UNIVERSITY OF MINNESOTA

Reply to Notice of Violation:

NOTICE OF VIOLATION

RADIATION SAFETY CONCERNS

RADIATION PROTECTION SURVEY

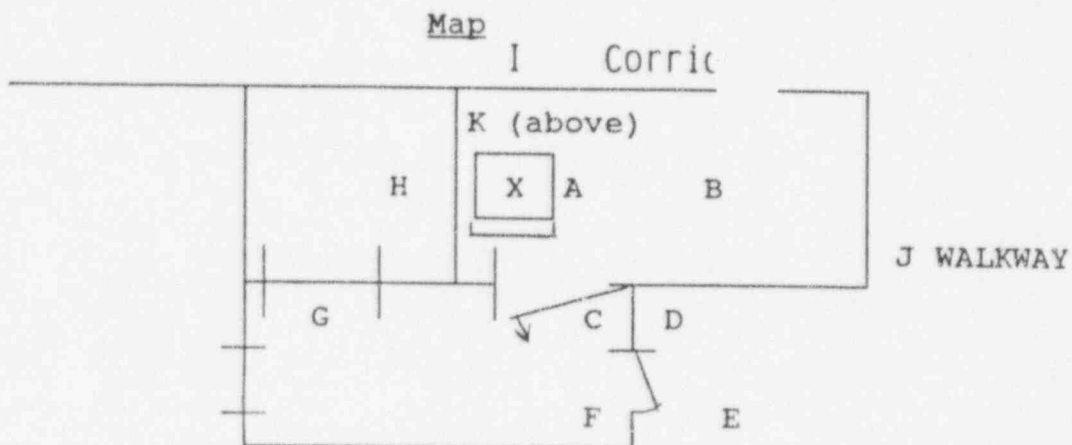
- 4A. A storage facility was established to house in a safe manner the additional brachytherapy Cs-137 tube sources that were purchased by our institution. Such purchase did not require NRC approval since the additional amount of Cs-137 did not cause our inventory to exceed our license possession limit for this radioisotope. The storage facility was approved by the Radiation Safety Officer and the Chairman of the Radiation Safety Committee prior to storing sources. An area survey conducted after the sources were in the facility documents that radiation exposure levels are within acceptable limits. It was our belief that our broad-scope license permitted independent action of the sort described without prior notification of the NRC.

Your license indicates that brachytherapy sources are stored in the MICRAD unit that is parked in the nuclear medicine hot lab. Your February 2, 1993, response included a description of an additional brachytherapy source storage facility that is located in Radiation Oncology. This additional storage location requires amendment of your license.

To rectify the deficiency, we hereby submit the facility for review and approval of the NRC. Attached is a copy of the radiation protection survey performed at time of first use of the facility. The area is in a limited access, low occupancy storage area that has both good lighting and ventilation. Both doors (positions C and E) are kept locked and are posted with radioactive material warning signs. The actual sources are kept in a locked lead safe (position X). To prevent future violations of this sort, we will submit all changes in facilities for review by the full Radiation Safety Committee (RSC). Where questions arise about whether the NRC must be informed, the RSO will contact the NRC for clarification. NRC review and approval will be solicited where appropriate.

Please prepare a request to amend the license for the brachytherapy source storage facility located in Radiation Oncology. The license amendment request should be sent to:
